APPLICATION OF KENTUCKY UTILITIES)	
COMPANY FOR AN ADJUSTMENT OF ITS)	CASE NO.
ELECTRIC RATES AND FOR CERTIFICATES)	2016-00370
OF PUBLIC CONVENIENCE AND NECESSITY)

RESPONSE OF
KENTUCKY UTILITIES COMPANY
TO
KENTUCKY CABLE TELECOMMUNICATIONS ASSOCIATION'S
FIRST REQUEST FOR INFORMATION
DATED JANUARY 11, 2017

**Response to Kentucky Cable Telecommunications Association's
First Requests for Information
Dated January 11, 2017**

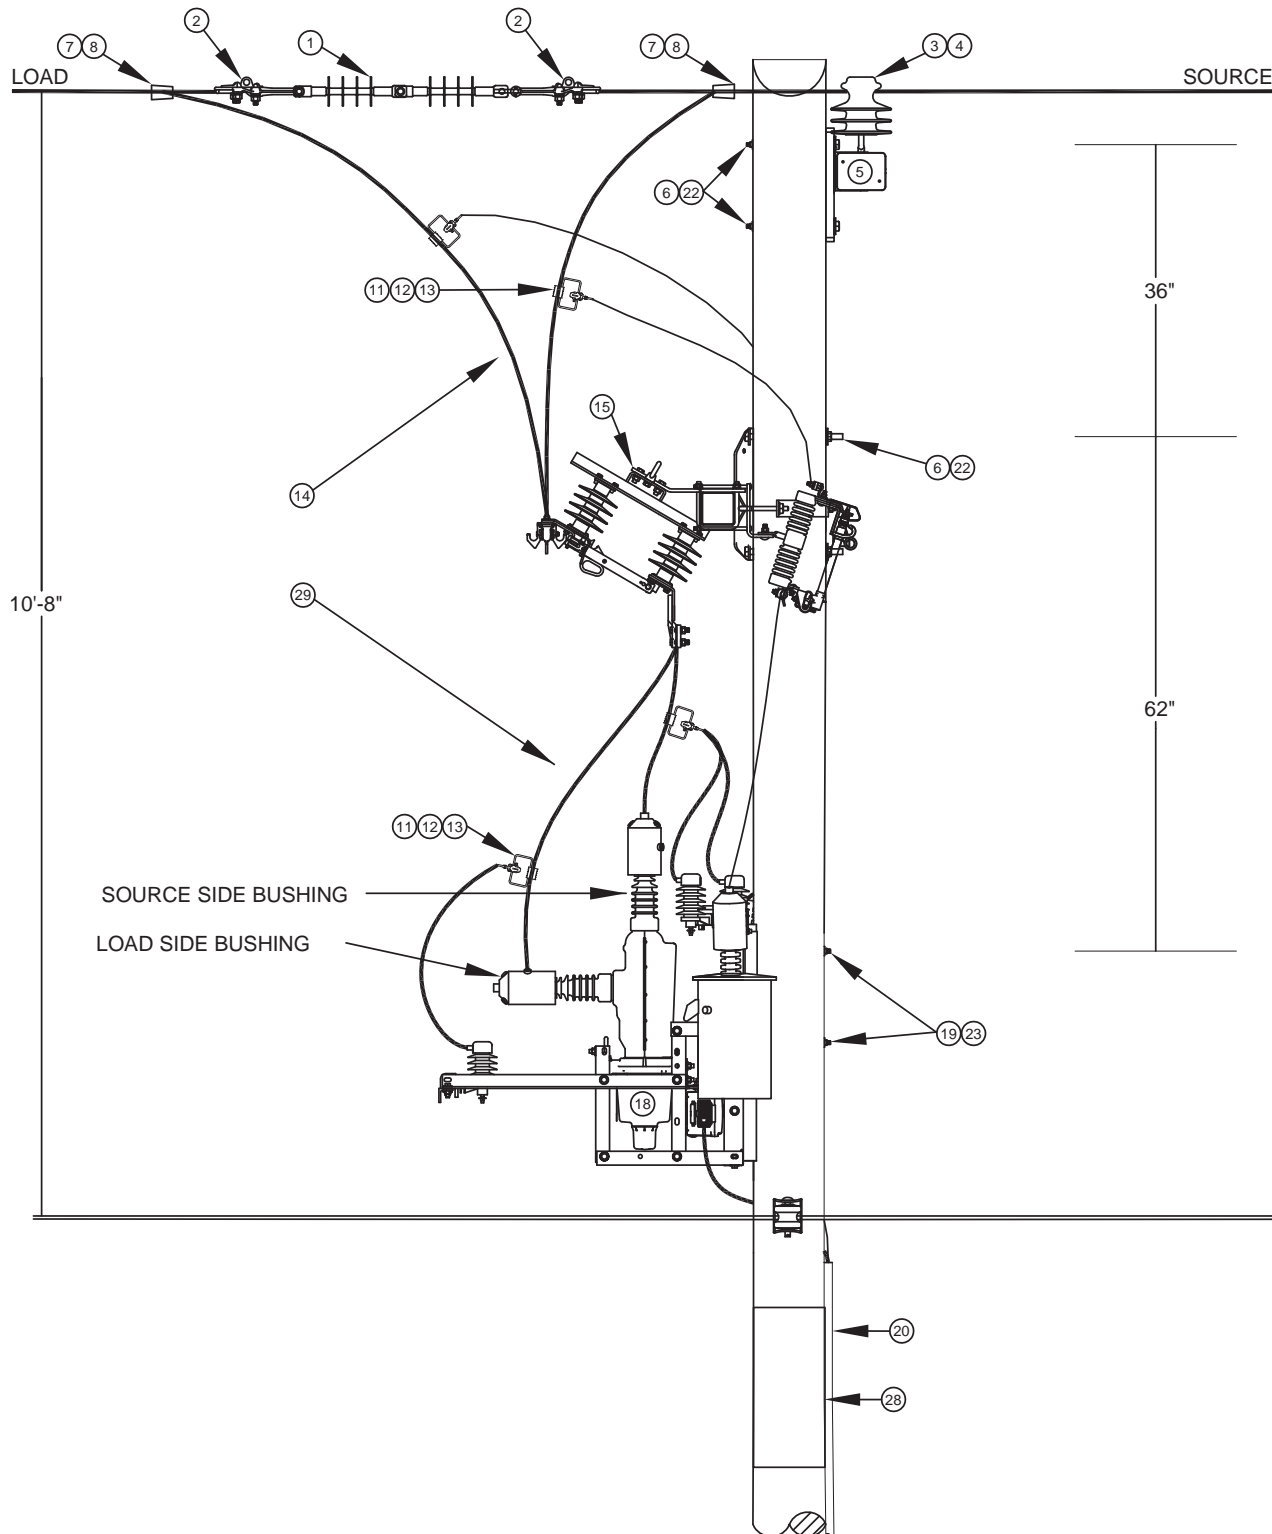
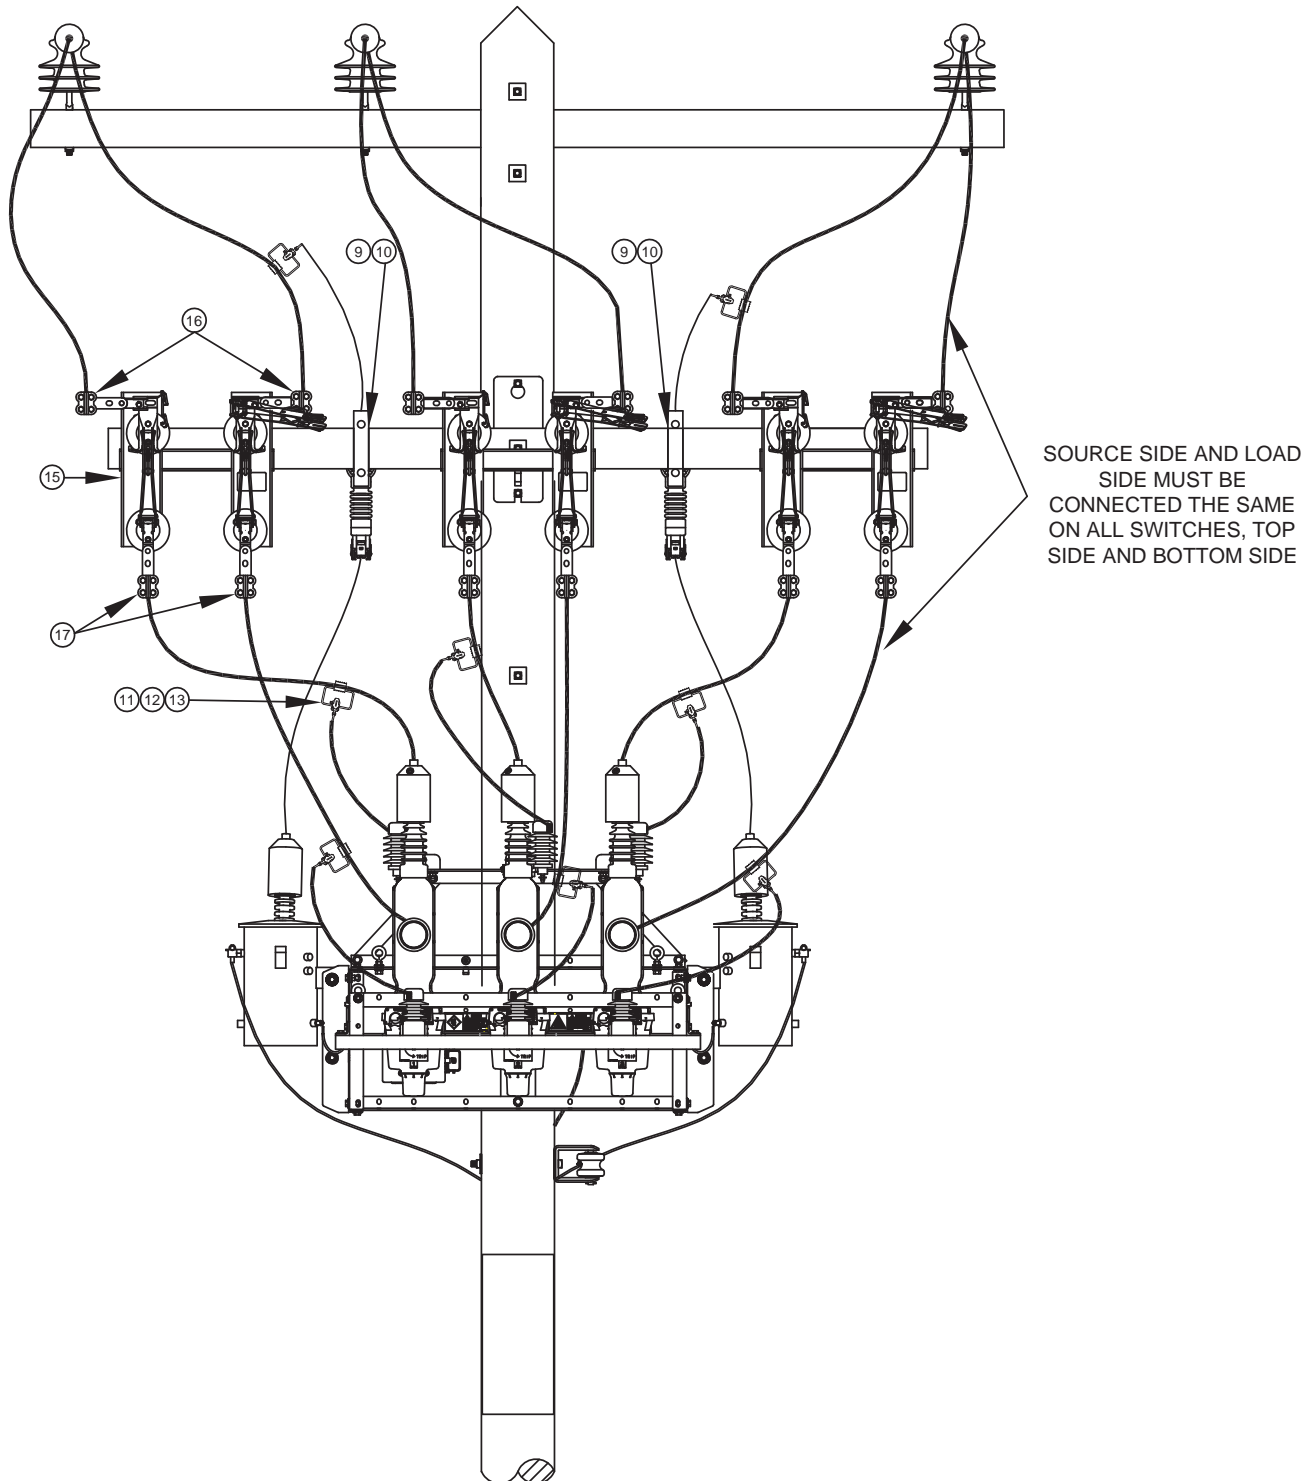
- a. Provide data related to any proposed installation of meters and/or equipment necessary to support the meters on Your Poles. Please include data showing where the equipment will be located and changes to existing pole facilities and Attachments that may be required to accommodate proposed AMS and DA systems as well as the basis for any such changes.

A-1-24. The AMS system will require the installation of radio-frequency (RF) communications infrastructure on distribution poles. This infrastructure facilitates the transmission of the meter data from the advanced meters to Company back-office systems.

The DA program will require the installation of electronic sectionalizing devices on distribution poles. The current company standard provides adequate clearance for the electronic sectionalizing devices between primary and neutral conductors. Poles with legacy construction standards may require the installation of a taller pole or the lowering of the system neutral. A control box will be mounted at the base of the pole 5 feet from ground level. All cabling required from the control box to the electronic sectionalizing device will be protected by armoring the cable and installing the unarmored sections of cable in conduit or other acceptable means of protection. See the attached for an illustration of the Company's standard installation of a SCADA capable recloser.

- a. See attached for data illustrating the Company's standard related to the installation of AMS router infrastructure.
